# MDS-MX1

# SONY. SERVICE MANUAL

# **SUPPLEMENT-1**

**Subject: 1. CORRECTION**

#### How to discriminate (Over write head)

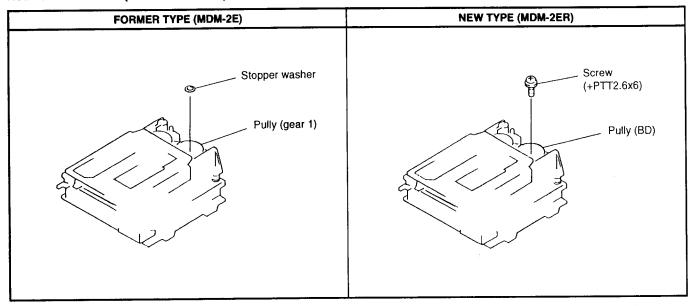
The over write head has changed.

According to this change, the service form will be changed, so refer to How to discriminate (Over write head).

FORMER TYPE	<u></u>			NEW TYPE	
	ня90	153			HR9	2001	
Ref No.	Part No.	Description	Remark	Ref No.	Part No.	Description	Remark
153 HR901	1-654-446-11 1-500-175-11	OWH FLEXIBLE BOARD HEAD, OVER WRITE (RF322-74A)		HR901	1-500-304-21	not used HEAD, OVER WRITE

The new part can be used instead of the former over write head.
